BURNT HILL BRIDGE OVER LITTLE BENNETT CREEK MANDATORY REFERRAL (MR2025014)

No. MR2025014

05/01/2025

Figure 10: Extent of Stream Work

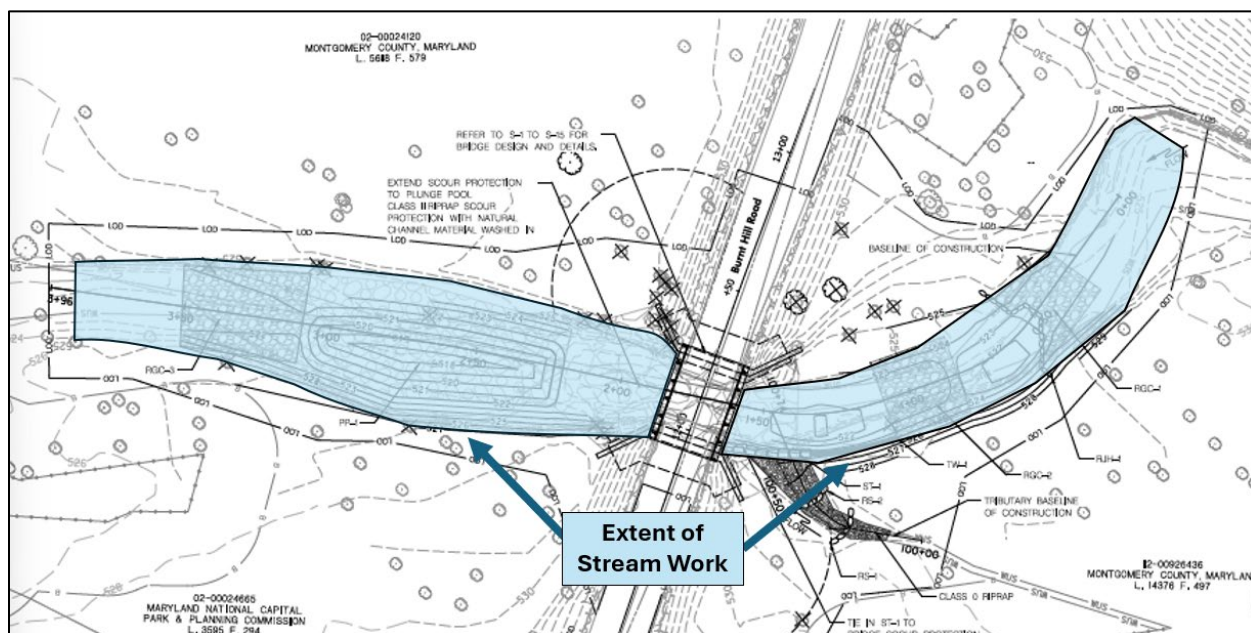
MCDOT will include Natural Channel Design instream stabilization and enhancement features (per Parks Standard Details) upstream (~200 feet) and downstream (~225 feet) of the new bridge. Traditional bridge construction techniques generally reduce the stream width and harden the banks, which accelerates stream flows and increases the erosive force of the water. However, this proposed bridge will be approximately 10' 9" longer than the existing bridge and will accommodate larger stormflows, less erosive flows, and improved aquatic passage. Montgomery Parks appreciates MCDOT's commitment to improving the stream condition at Little Bennett Creek by building a new bridge with more capacity for the stream and restoring eroded banks upstream and downstream of the bridge. In addition, stream habitat will be improved by the construction of stable riffles and pools that provide varied aquatic habitat. Finally, the drainage channel from the existing wetland upstream of the bridge will be stabilized with rock sills and rip-rap material, and will tie into the existing stream channel.

3. MCDOT will continue to coordinate with M-NCPPC on the design of the required instream structures in Little Bennett Creek to ensure that a stable stream setting is provided.

Figure 11: Area of Proposed Right-of-Way, highlighted in yellow.

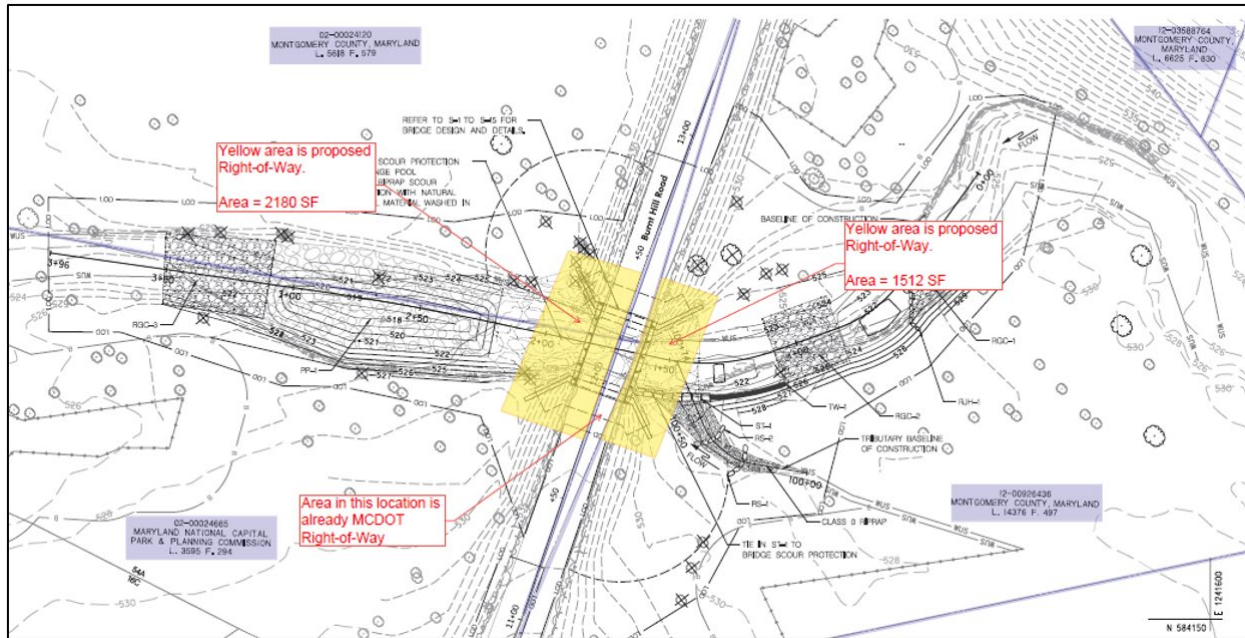
The current project design requires approximately 2,180 square feet (0.05 acre) of Little Bennett Regional Park and approximately 1,512 square feet (0.035 acre) of Little Bennett Creek Stream Valley Park to be added to the MCDOT ROW to accommodate the new bridge structure, creating a permanent impact to the park.

Since the funds used to acquire this land were appropriated to the Commission for parks and open space purposes, M-NCPPC Montgomery Parks must be compensated at fair market value for the land area that will no longer be serving park purposes. Payment for the new ROW area must be made to Montgomery Parks prior to issuance of the Park Construction Permit. Commission land that is proposed to be transferred to MCDOT is highlighted in Figure 5 below.

2. MCDOT must compensate the M-NCPPC at fair market value for all land that will transfer from M-NCPPC to MCDOT's road right-of-way (ROW), estimated at approximately 3,692 sf. Payment for the transferred land must occur before issuance of the Park Construction Permit. The new ROW will be transferred to MCDOT by M-NCPPC via a Release Agreement and via perpetual easement, recorded in the County Land Records.
